Additional Council Meeting - 13 December 2022 Attachments

4.1. PP2022-0052 - 19 PRESTON STREET, DENNINGTON.....2

Delegate Planning Assessment Report

Application is for:	Construction of three (3) dwellings (following demolition of existing)
Applicant's/Owner's Name:	Planning and Design Pty Ltd 31 Enfield Ave PRESTON VIC 3072
Date Received:	10 March 2022
Statutory Days:	147 @ 16 November 2022
Application Number:	PP2022-0052
Planner:	Nick Legoe – Senior Statutory Planner
Land/Address:	ALLOT Lot 1 TP 961744Y PSH WAN TSH DENN 19 Preston St DENNINGTON VIC 3280
Zoning:	General Residential Zone – Schedule 1
Overlays:	Nil
Under what clause(s) is a permit required?	Clause 32.08-6 – Construction of two or more dwellings on a lot.
Restrictive covenants on the title?	Nil
Current use and development:	Single Dwelling

GROUND FLOOR PLAN
UNIT DEVELOPMENT
19 PRESTON STREET,
DENNINGTON
TP01
REV_8

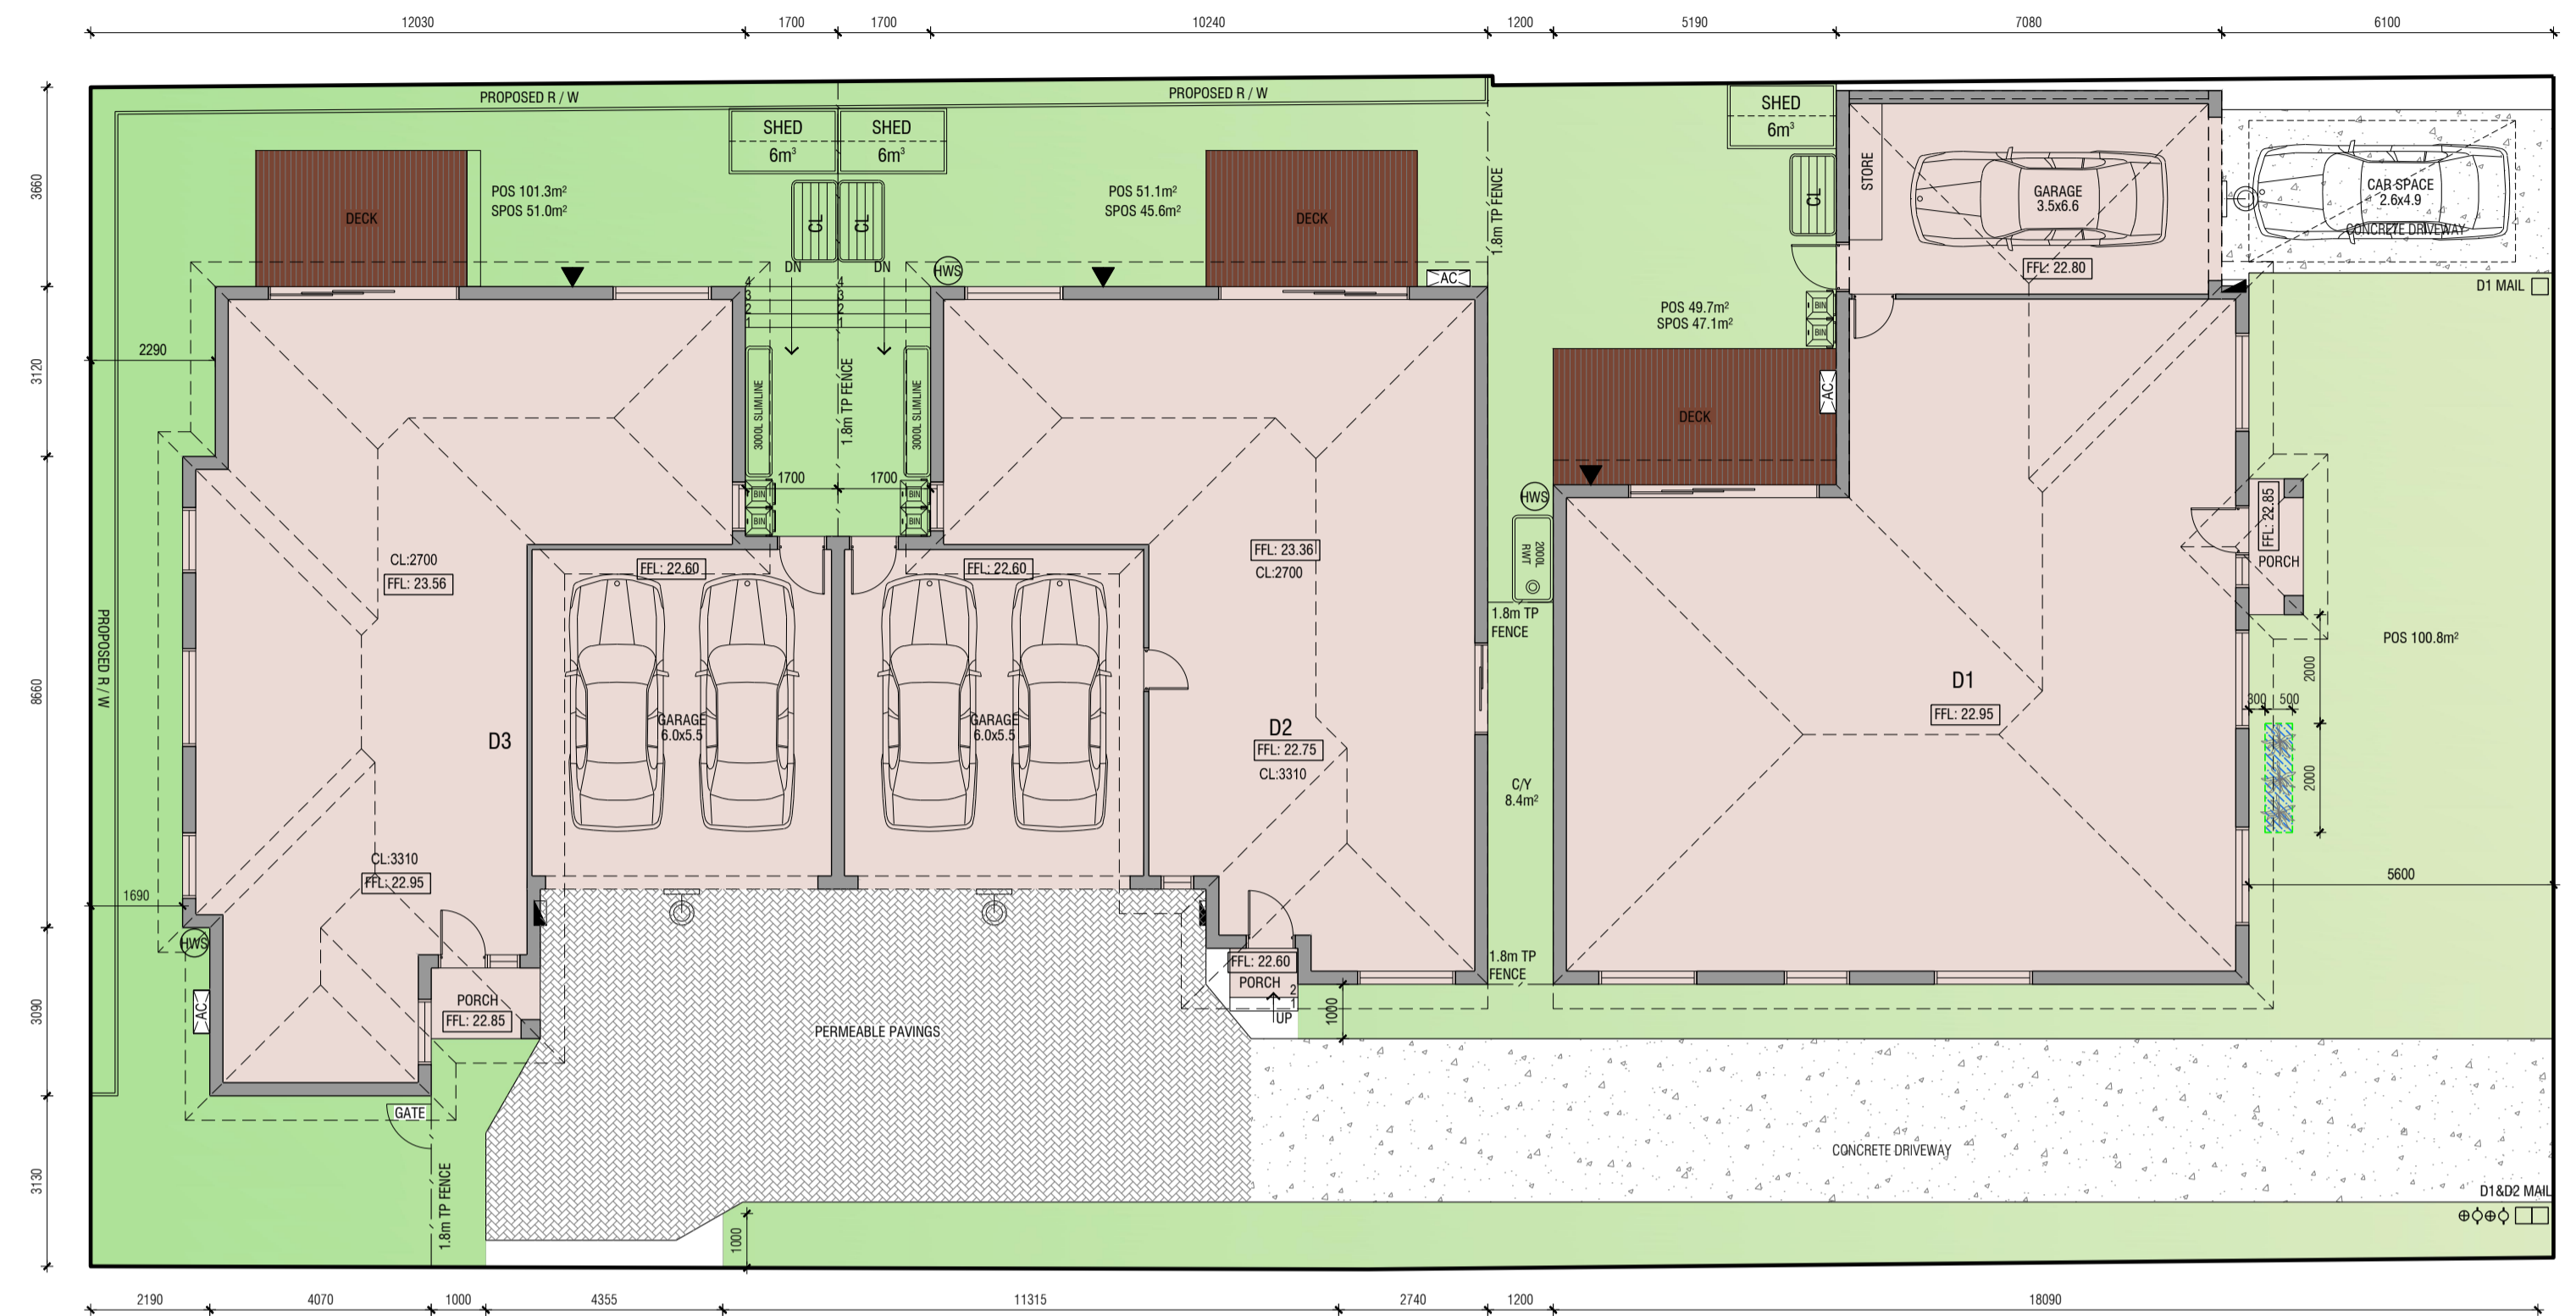
Please refer to the Ground Floor Plan, we show the collection bins spaces along the frontage(1 meter between the bins). Therefore, we believe that it is not affected the council bins collection.

The response from the applicant also provided an amended site plan which depicted a bin collection area in front of the site.

It is noted that Council Officers were of the view that this plan was submitted for information purposes only and did not constitute a formal plan amendment.

- a. The bin collection area within the street verge depicted on the Site Plan removed.
 - b. The location of the two vehicle crossovers with a note confirming as existing or proposed as relevant.
 - c. The following note included on the Site Plan 'existing redundant crossovers to be reinstated to kerb and channel to Council Standard'.
 - d. Corner splays in accordance with Clause 52.06-9.
2. The development as shown on the endorsed plans must not be altered without the prior written consent of the Responsible Authority.
 3. Before the commencement of construction a detailed Stormwater Management Plan is to be submitted to and endorsed by the Responsible Authority. The stormwater works must
